Department of Energy
Washington, D.C. 20545

Docket No. 50-537

RESPONSES TO REQUEST FOR ADDITIONAL INFORMATION

Reference: Letter, P. S. Check to J. R. Longenecker, "CRBRP Request for Additional Information," dated February 19 and 26; March 11, 15, 23, and 25; and April 9, 1982

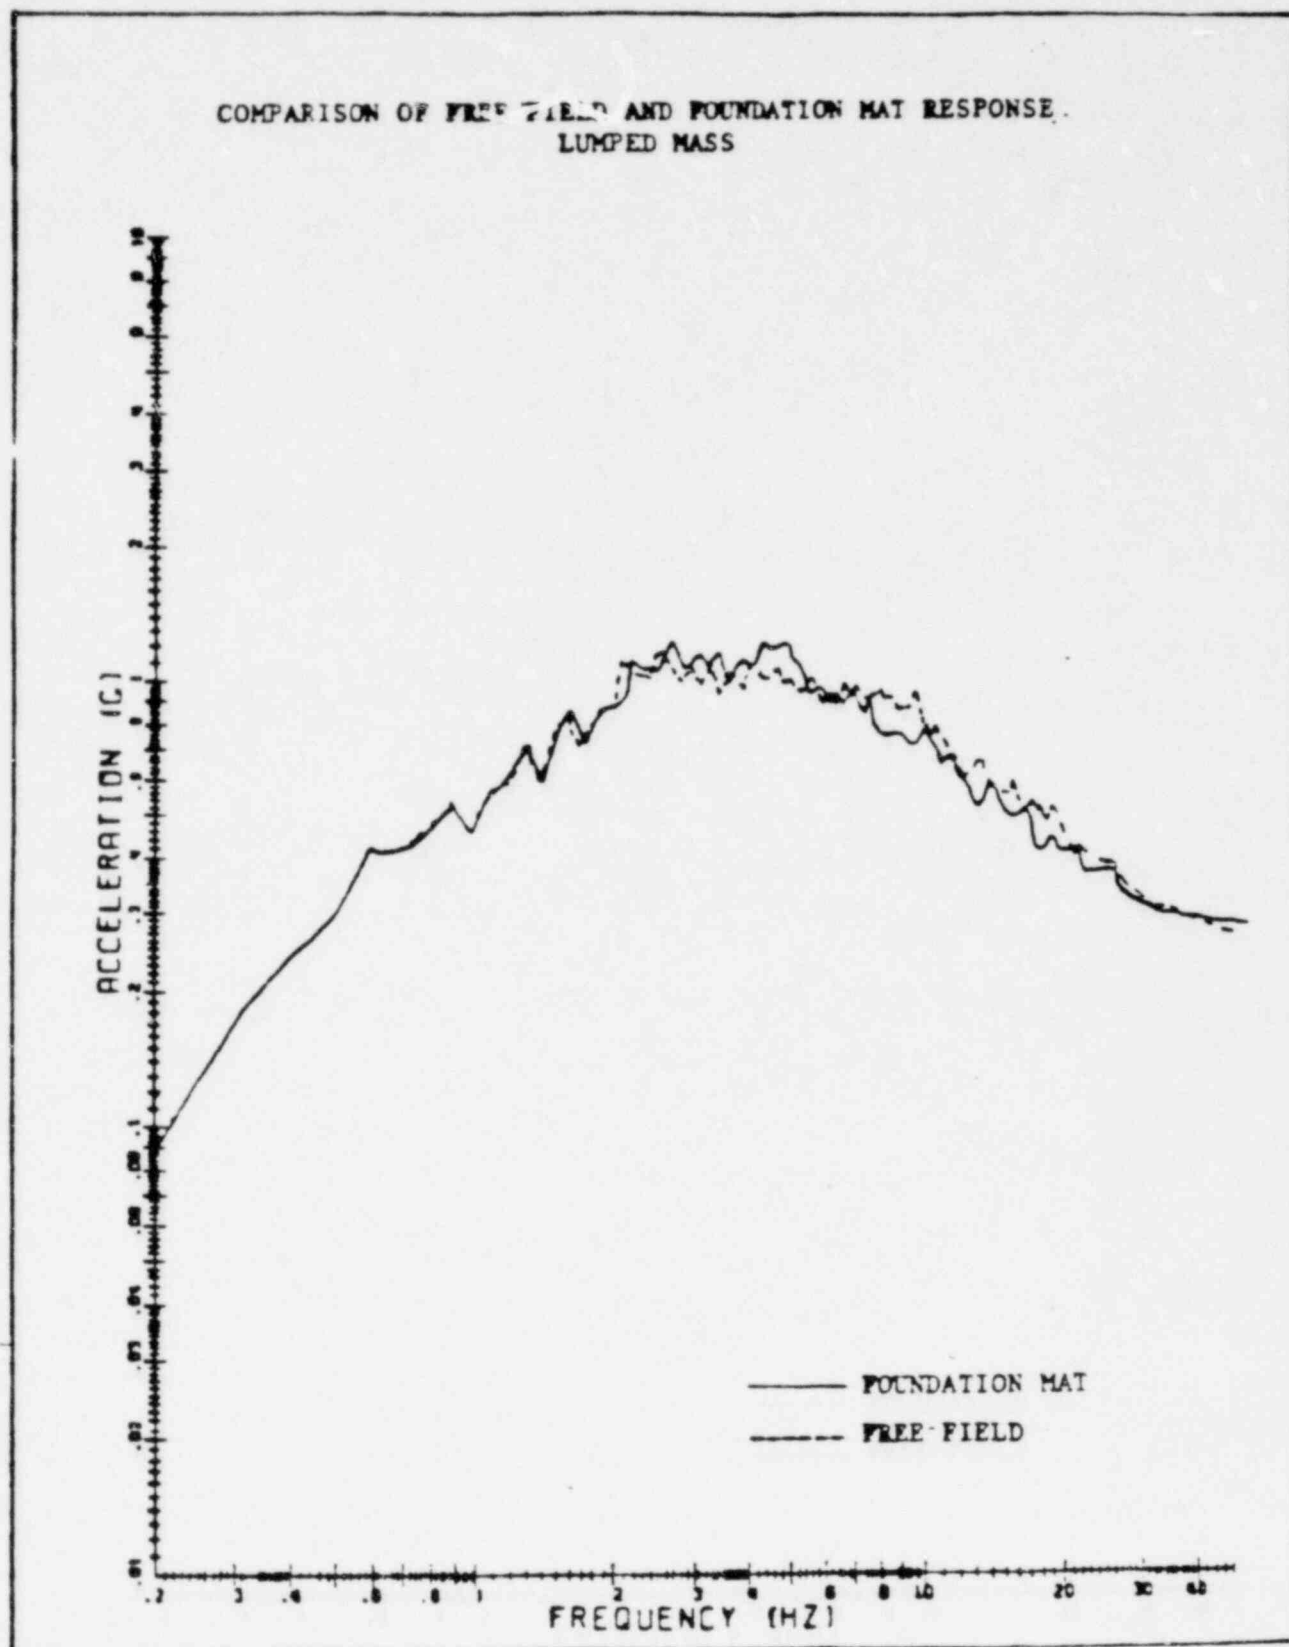
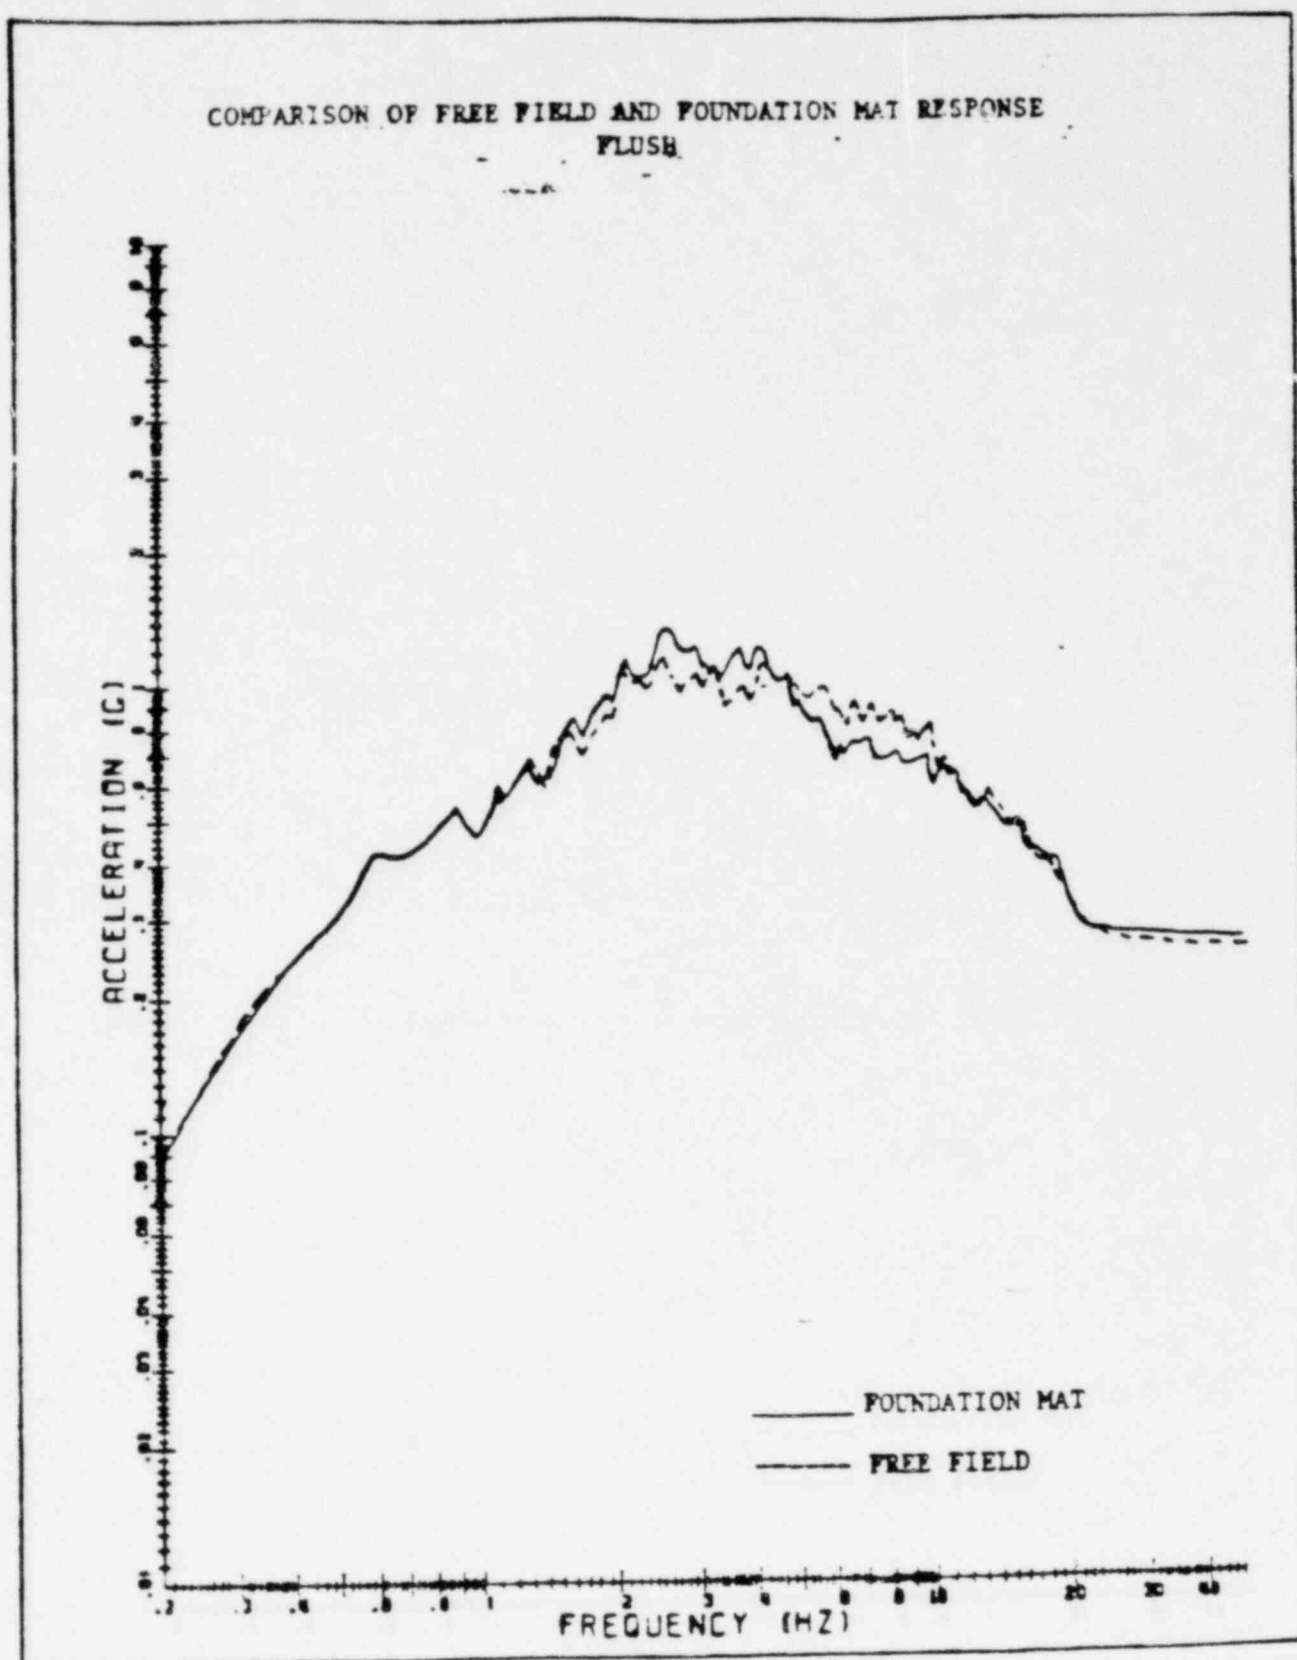
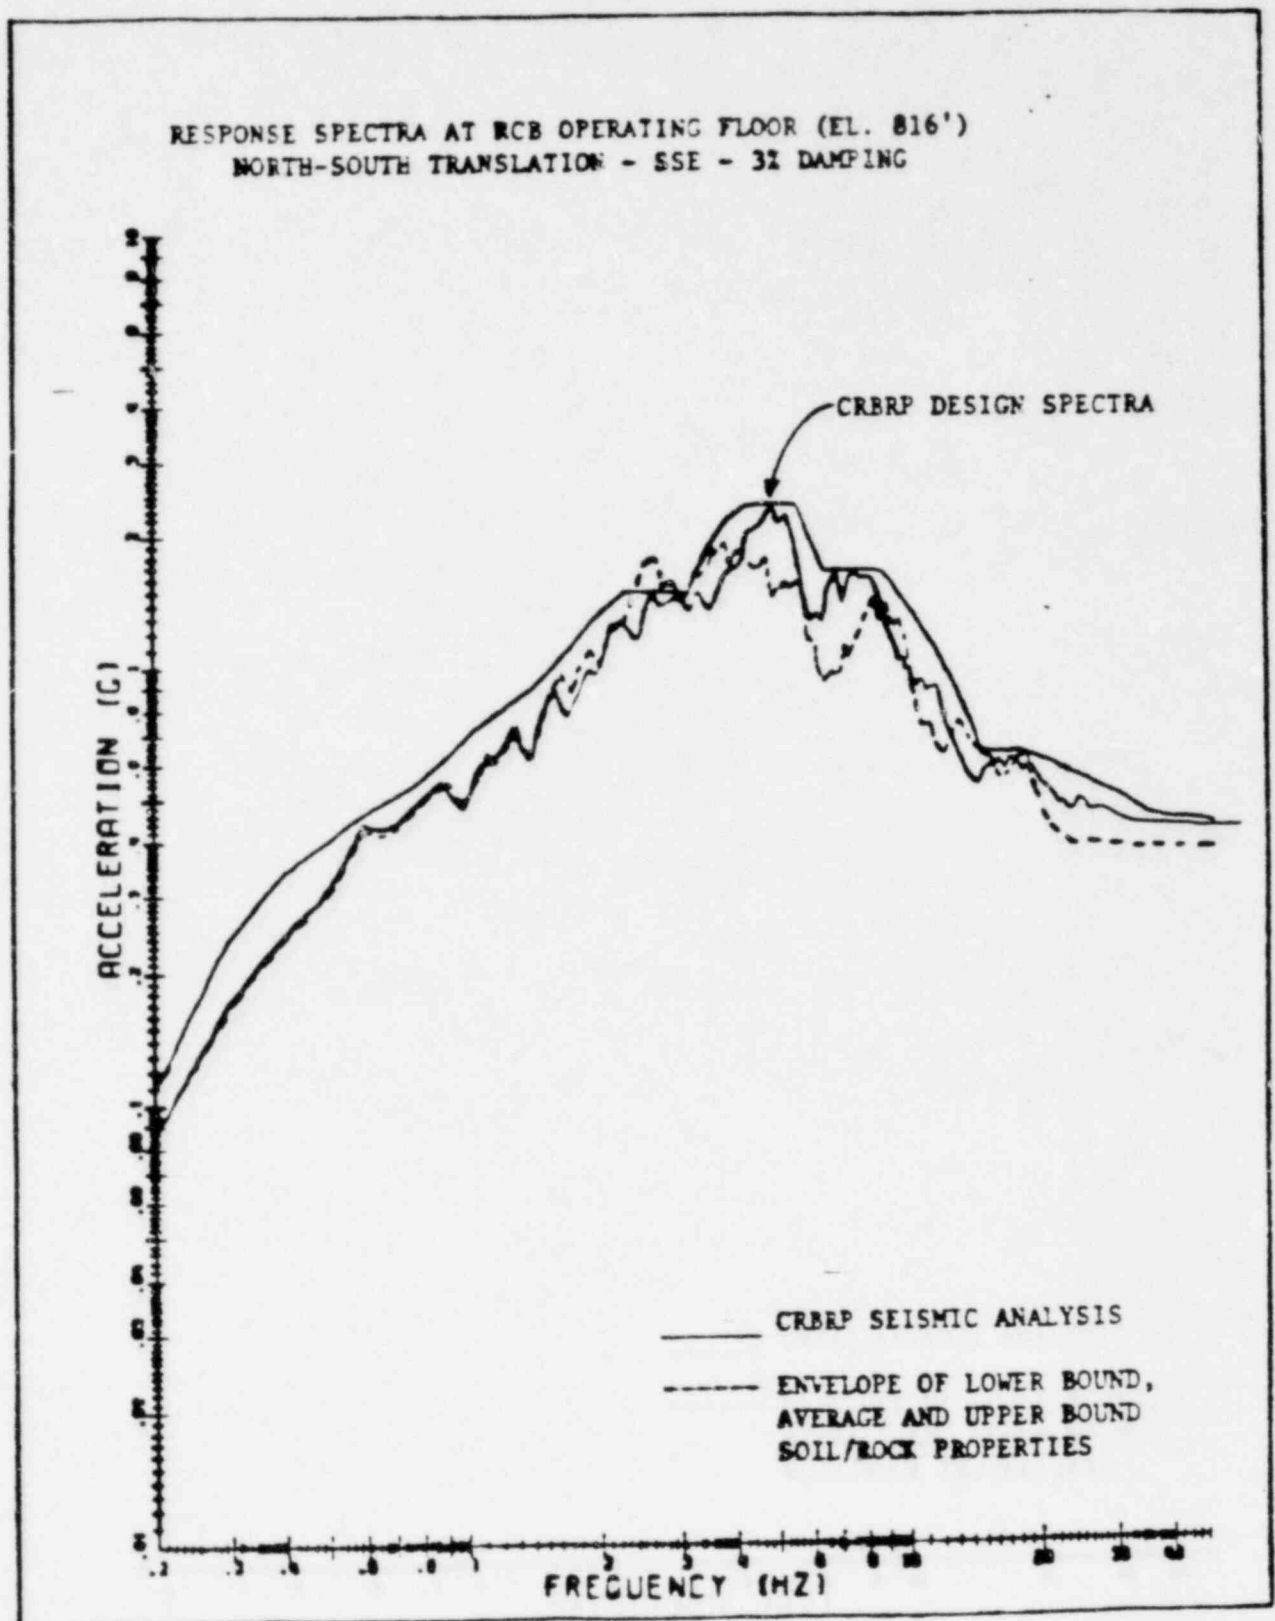
The major seismic Category I structures of the CRBR plant are supported on a common basemat founded on competent rock with an embedment of 100 ft of back fill. Under such a condition, it appears most appropriate to consider the structures as fixed at the foundation.

Additional analysis, using a different analytical approach (the Computer Program FLUSH) showed that the free-field and in-structure seismic responses at the foundation level differed, confirming that rock(soil) structure interaction will occur (Figure Q220.5-2).

An independent finite element analysis using the FLUSH program was performed to compare floor response spectra with the CRBRP design spectra. The CRBRP spectra in essence envelopes the calculated spectra and spectra generated from the CRBRP and finite element analyses are very similar (Figure Q220.5-3).
